**DEVIATION REQUEST  
AND DECISION FORM**

Project Name : Village at Lorson Ranch Filing 1  
 Schedule No.(s) : 5515413054  
 Legal Description : See Attached

**TRAFFIC EXHIBIT  
 PROPOSED ALTERNATIVE**  
 August 7, 2024

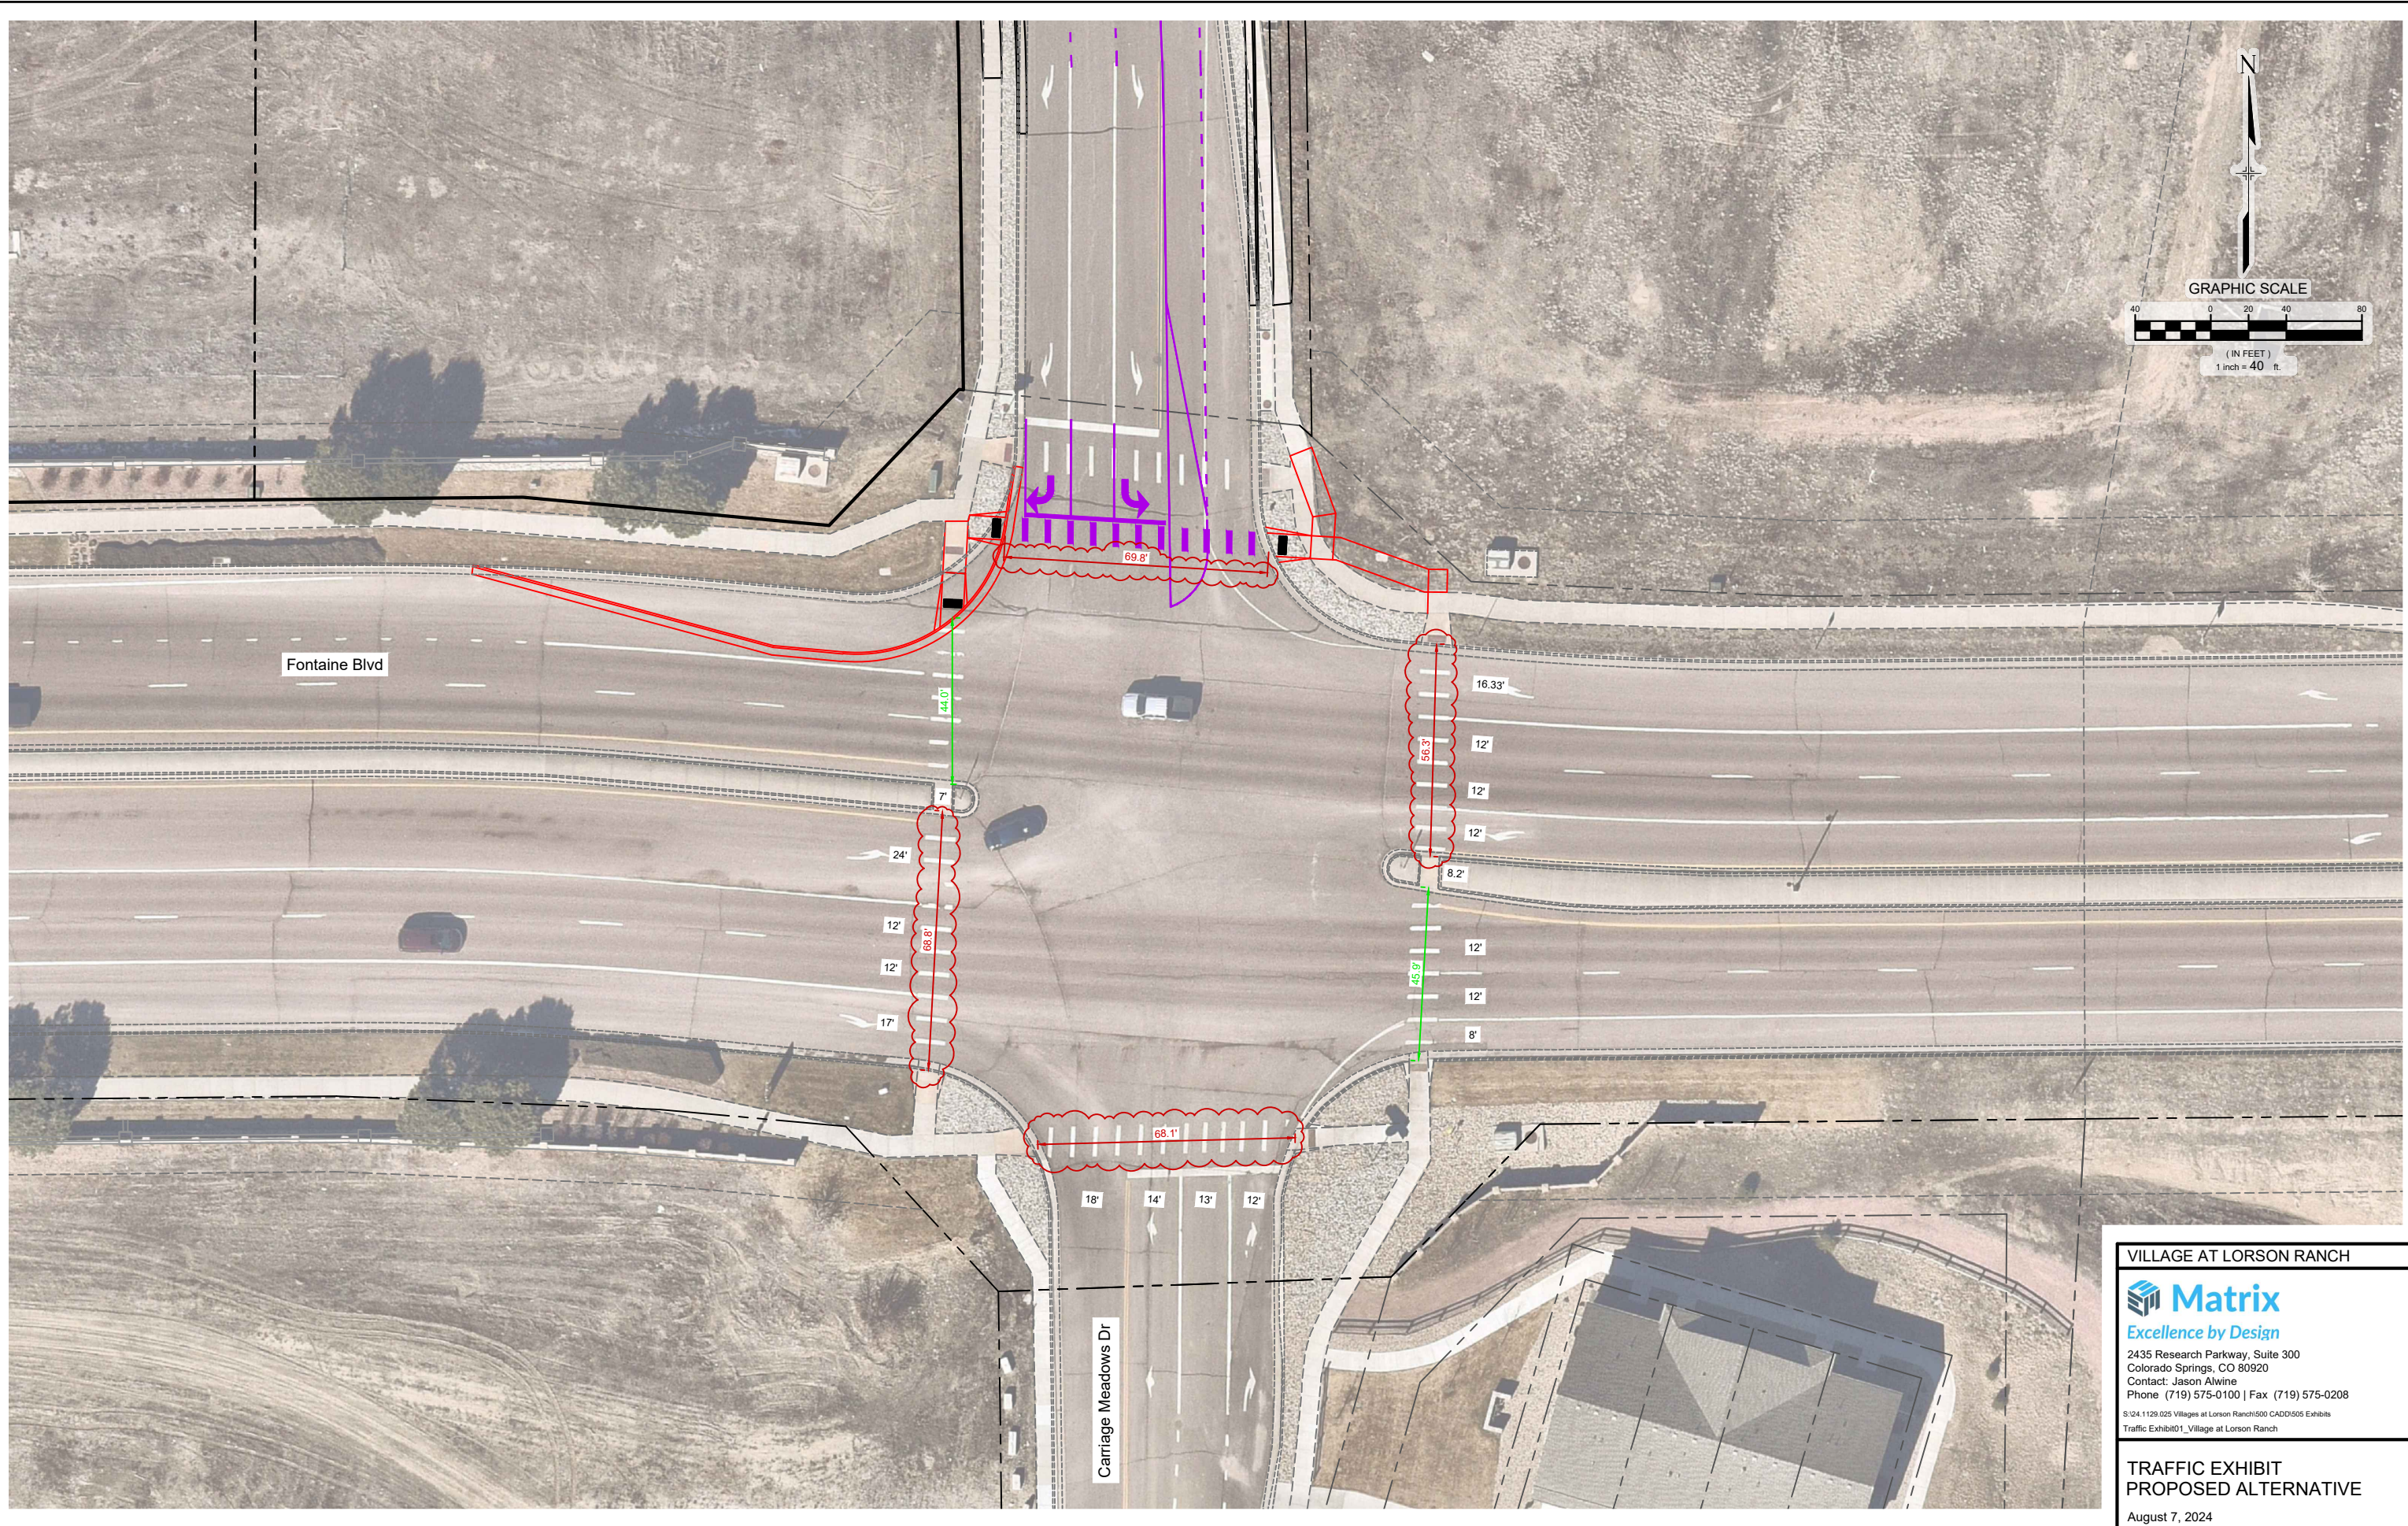
2 of the 4 crossing locations at the intersection of Fontaine Blvd and Carriage Meadows Drive will have a crossing length greater than 48 feet and no refuge islands. The other 2 crossing locations have existing refuge islands but also have crossing lengths greater than 48 feet. (See attached exhibit)

The proposed alternative to the ECM standard is requested because of the considerable amount of modification and expansion to accommodate pedestrian refuge pork chop islands at all 4 sides of the intersection. Modification would include relocation of (2) 6'x12' concrete electric vaults, relocate a 25' long Type R inlet, relocate a 5' long Type R inlet and reconstruct a portion of storm sewer, additional pavement/curb/sidewalk reconstruction and expansion, and ROW taking at 3 of the 4 intersection corners. MVEA has preliminarily indicated that relocation of the 2 vaults could reach the \$300k-\$400k range and they are not sure they could physically do the modification while keeping everyone's lights on in the area.

The proposed alternative is the continued use of the 2 existing refuge islands on Fontaine Blvd and allow for several crossing lengths longer than 48 feet. The deviation will allow for better visibility of oncoming traffic for right-turns out of the Carriage Meadows Drive intersection approaches. Currently, two pedestrian refuge areas exist when crossing Fontaine Blvd which are the longer of the 2 of 4 crossings (see attached exhibit). The other crossing locations do not meet the ECM standard because of exceeding the 48' by approximately 8 - 20 feet with no pedestrian refuge. At a pedestrian rate of 3.5' per second, the extra time required to cross this distance is approximately 2.3 - 5.7 seconds. No school sites or parks are near these crosswalks, and we believe the requirement of full pedestrian refuge pork chop islands would be excessive for this specific existing location. Corner refuge islands that will accommodate the WB-67 design vehicle necessary for the Fontaine Boulevard arterial classification will provide large radius turns that imply motorists can accelerate even though there is no receiving acceleration lane. Additionally, the configuration of the large radius corner refuge islands will make it difficult for motorists executing right-turns out of the Carriage Meadows intersection approaches to view oncoming vehicles because of the orientation of their vehicle at a greater than 90-degree angle to the direction of oncoming traffic.

This request has been determined to have met the criteria for approval. A deviation from Section 2.5.2.F.2 of the ECM is hereby granted based on the justification provided.
